**RE: Starbucks at Menaul & Carlisle
3535 Menaul Blvd. NE
Revised Grading and Drainage Plan
Engineer's Stamp Date: 10/24/19
Hydrology File: H16D083E**

Based upon the information provided in your submittal received 10/28/2019, the Revised Grading and Drainage Plan is approved for Building Permit, Grading Permit and SO-19 Permit and for action by the DRB on the Preliminary/Final Plat.

Starbucks Shell
Grading and Drainage Plan
Northwest Corner of Carlisle & Menaul
Albuquerque, New Mexico

Starbucks Shell
Grading and Drainage Plan

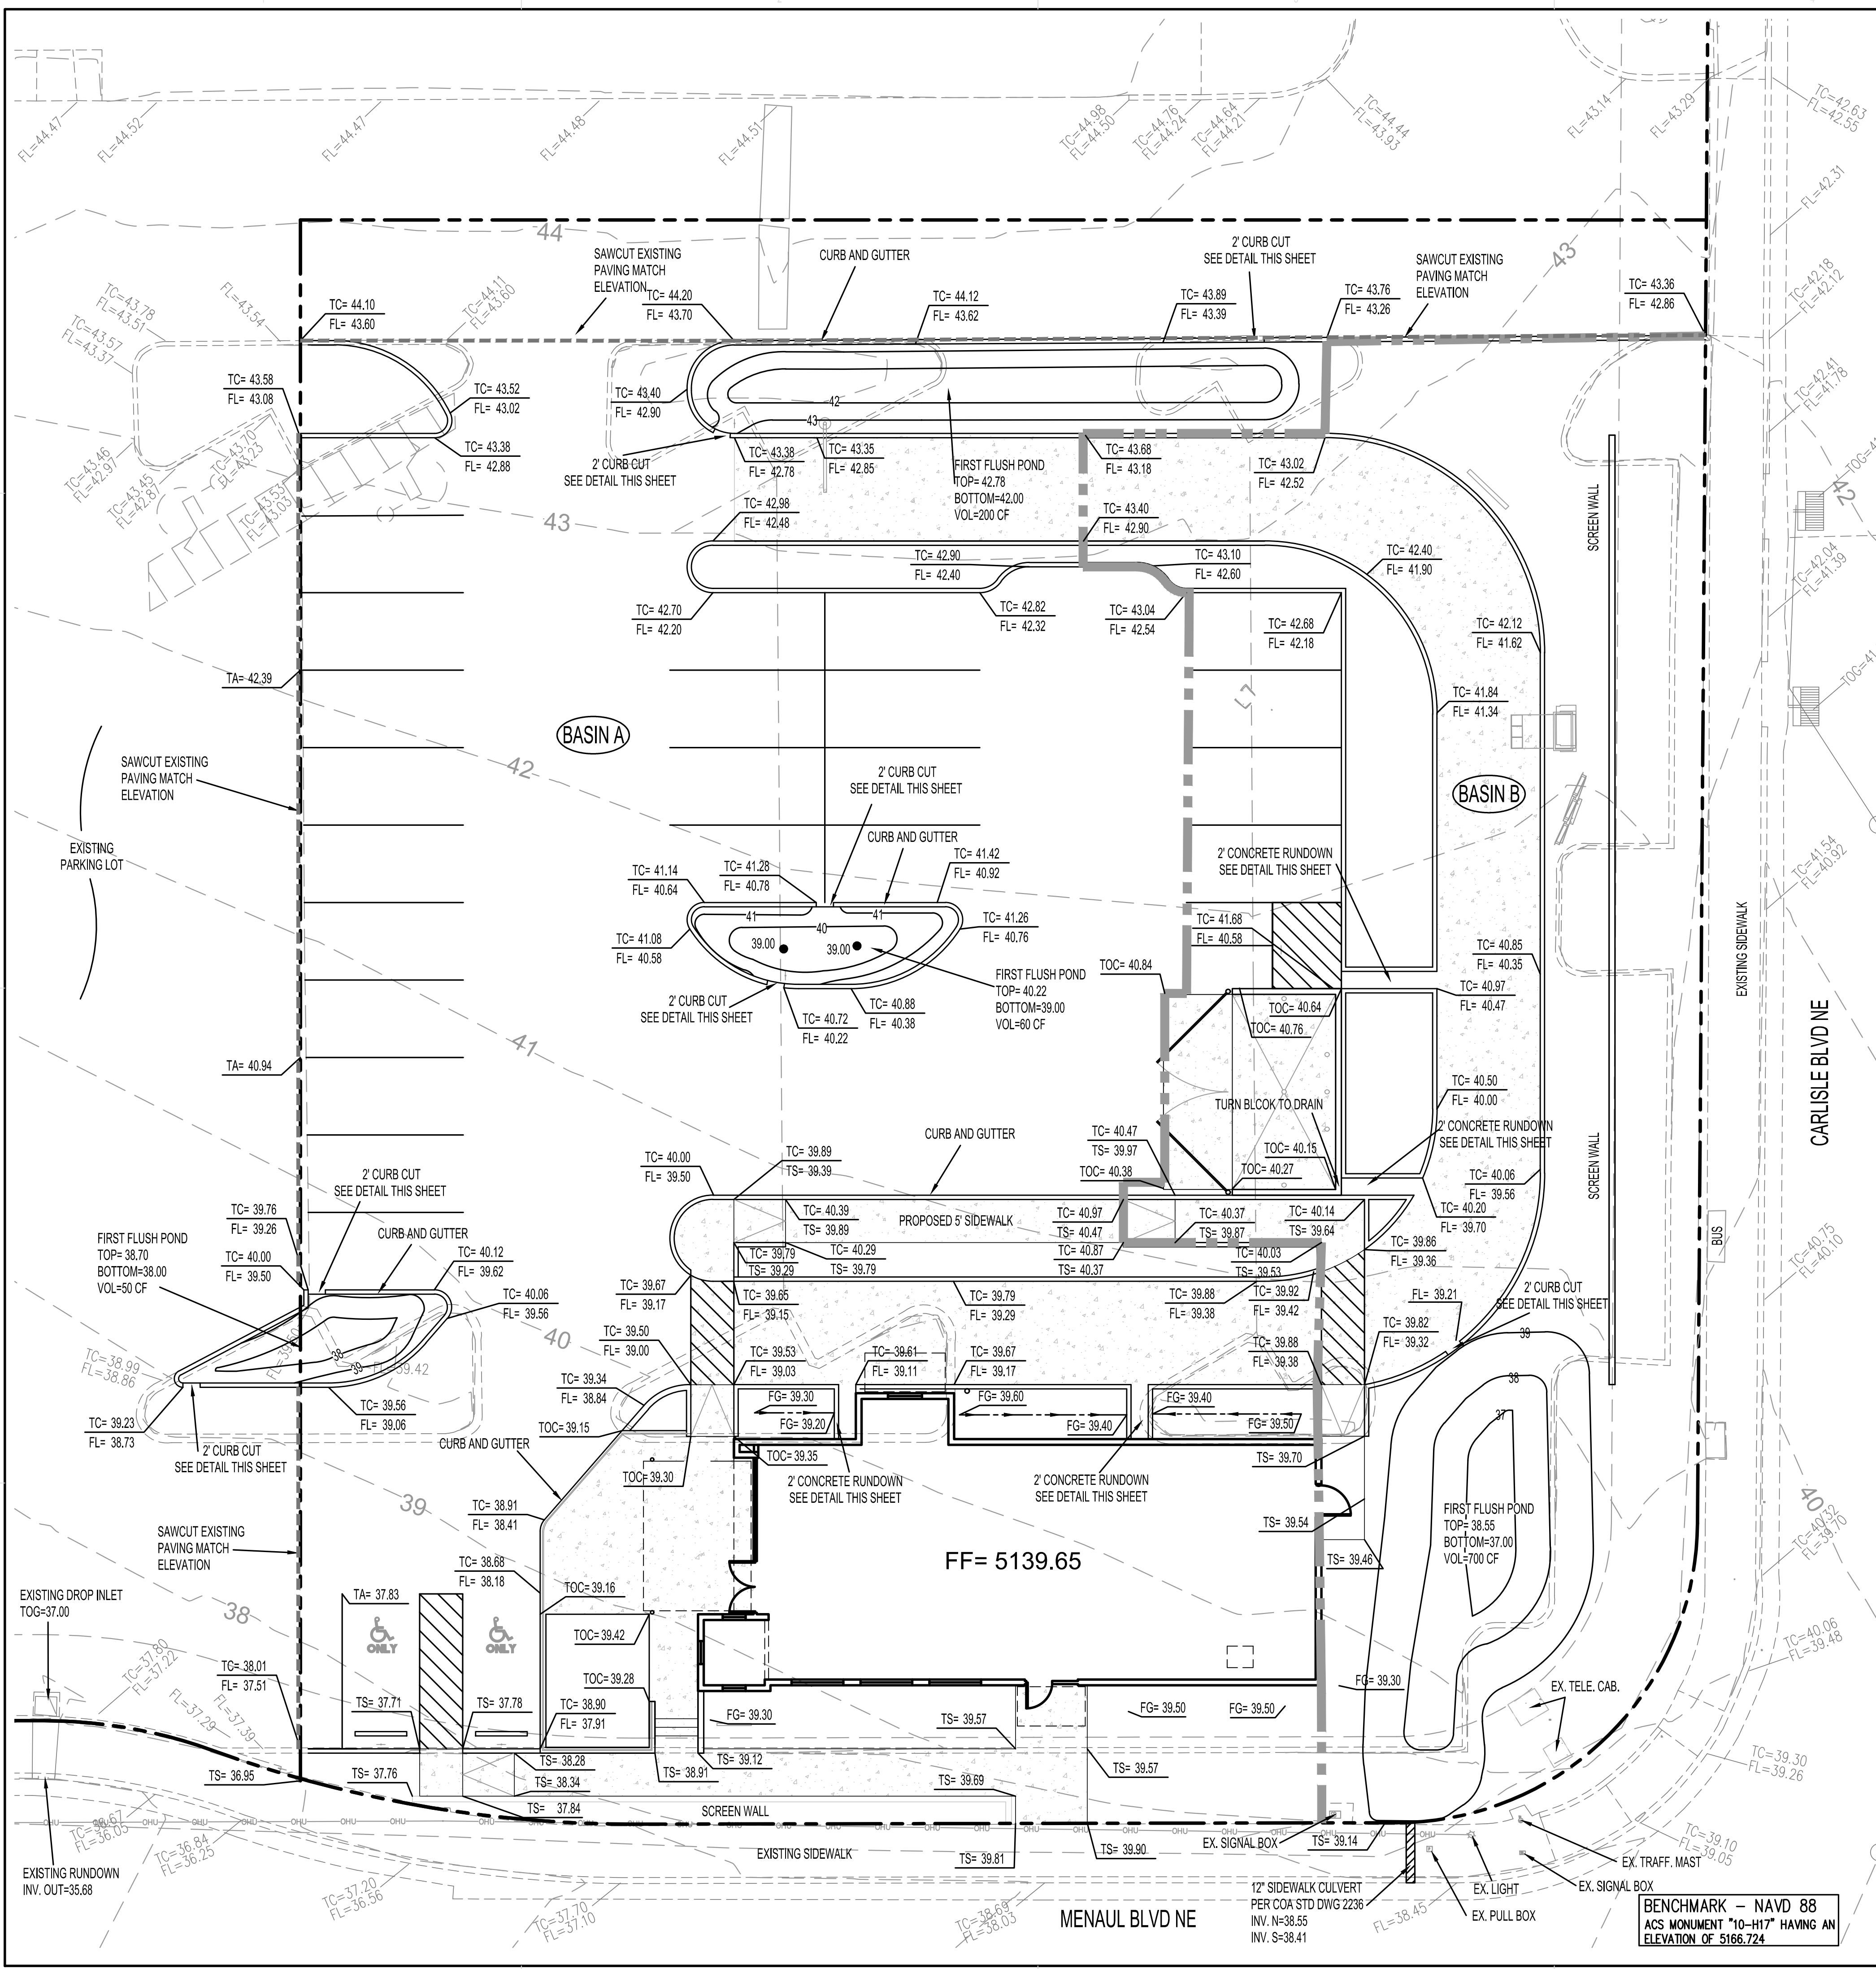
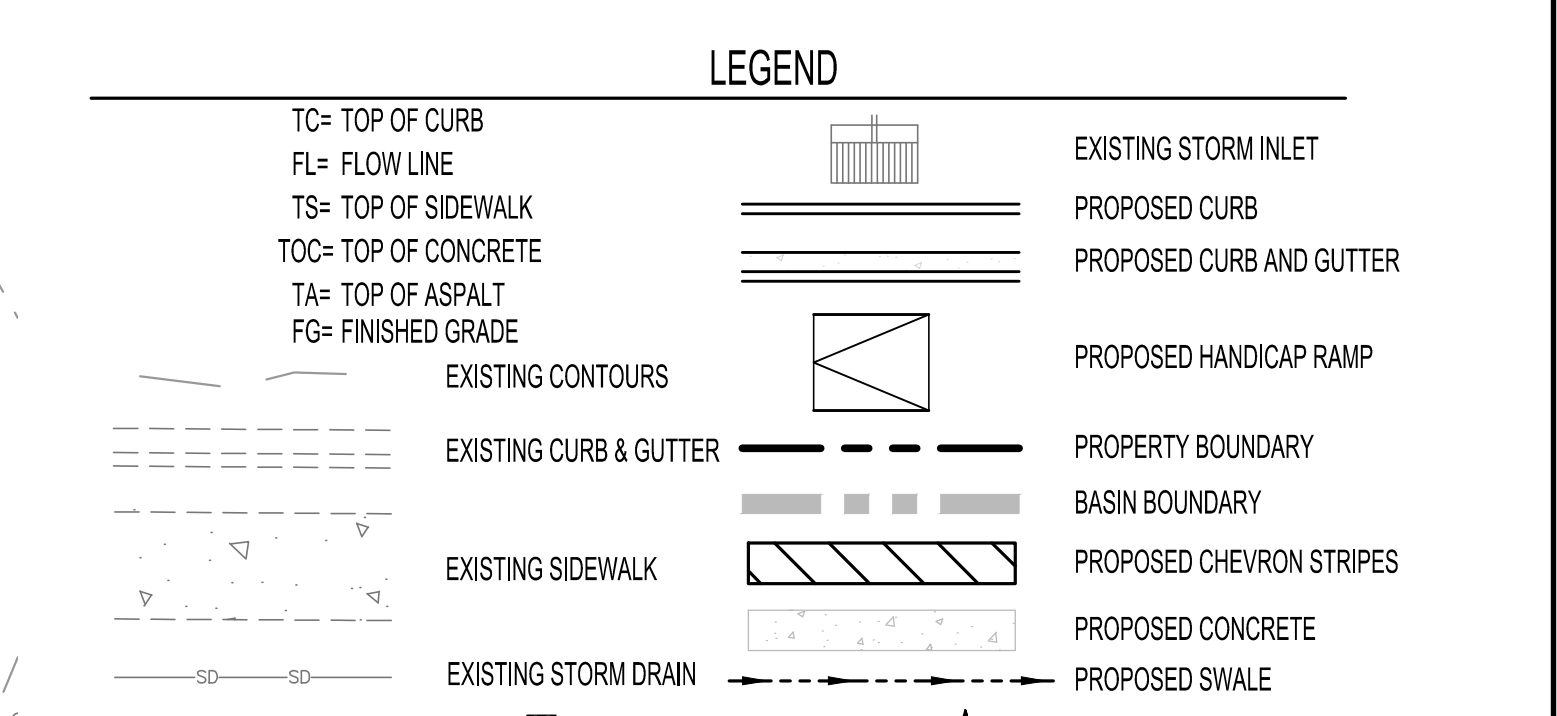
Please attach a copy of this approved plan in the construction sets for Building Permit processing along with a copy of this letter. Prior to approval in support of Permanent Release of Occupancy by Hydrology, Engineer Certification per the DPM checklist will be required.

Also as a reminder, please provide Drainage Covenant for the stormwater quality ponds per Chapter 17 of the DPM prior to Permanent Release of Occupancy. Please submit this on the 4th floor of Plaza de Sol. A \$25 fee will be required.
